GEOSHIELD Verification Report

GCL - Clarendon Road PHASE 3

AREA SURVEYED: Block D1 Slab - Pour 1.

DATE: 10/12/2020

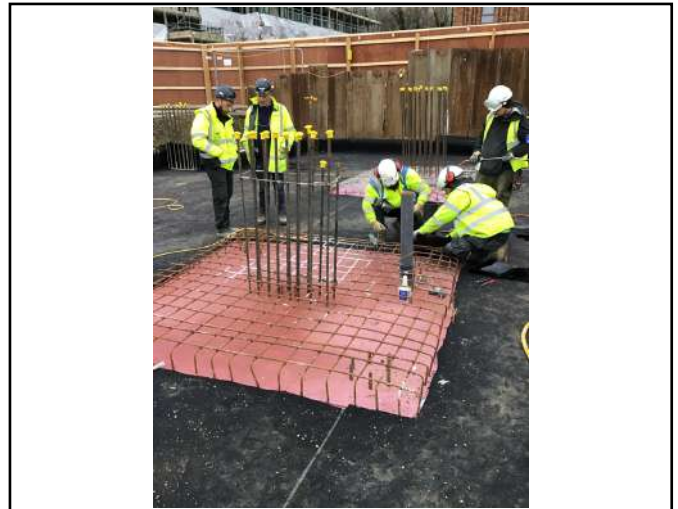
NOTES: Incomplete sealing of pipe penetrations.

The first photograph below shows a pipe penetration that was found unsealed during today's inspection visit. This was along with another two unsealed pipe penetrations.

The second photograph above shows a toolbox talk demonstration being carried out to the installers, demonstrating how to correctly seal the pipe penetration, as per manufacturers specification and design details.

All pipe penetrations will need to be sealed and re-verified during the next inspection visit to site.
